***Greenwood Fire & Rescue Facility***

809 Greenwood Rd  
Frederick County, VA

**Addendum #1**

SUMMIT USA Inc.		Greenwood Vol. Fire & Rescue		
DATE	REV	STYLE	HEIGHT	SLIDE PATH LENGTH
9/18/19	0	AD1080°	186"	47'
Minimum Water Flow	Minimum Water Depth	Maximum Weight		
n/a	n/a	400 lb

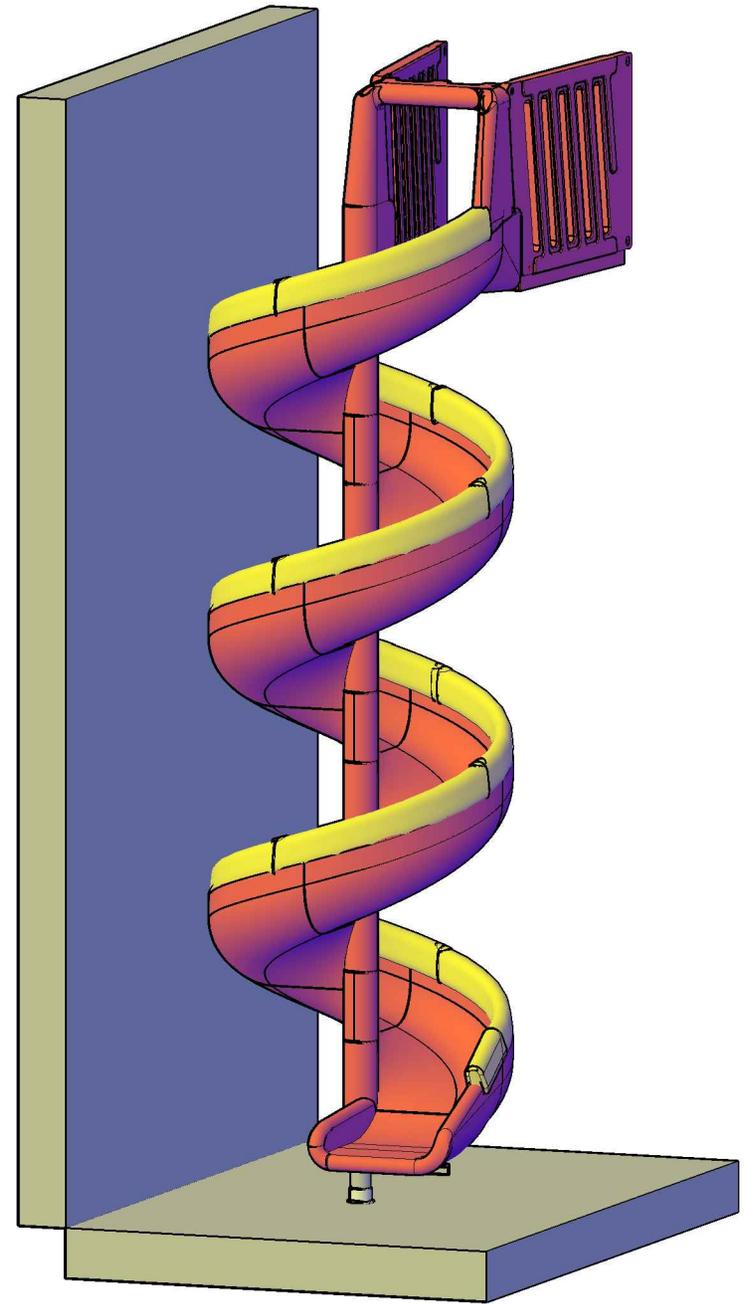
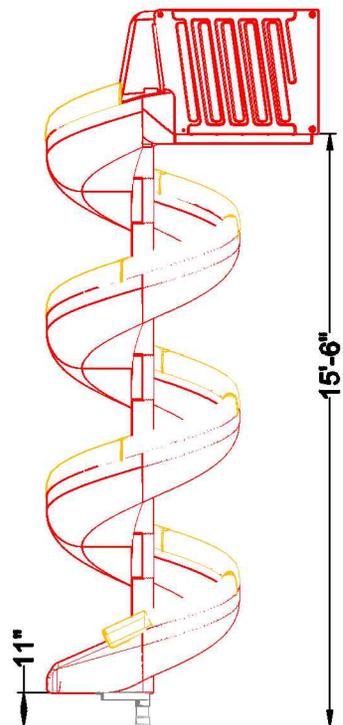
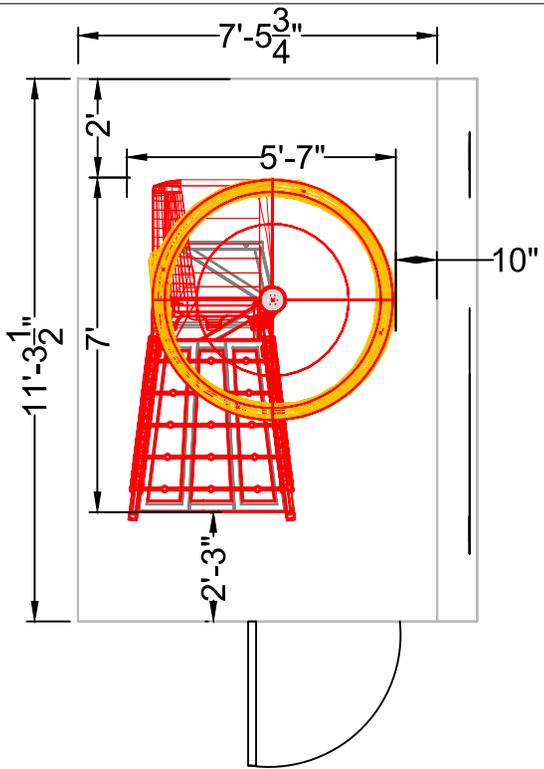
18. Do you have any specifications for the slide, or can you provide an acceptable vendor/supplier?

See attached Basis of Design. Max. budget \$31,000 for slide (material cost) includes shipping and handling. Please allow 6-8 weeks lead time.

Contractor to coordinate and install. Provide engineered shop drawings for review and approval.
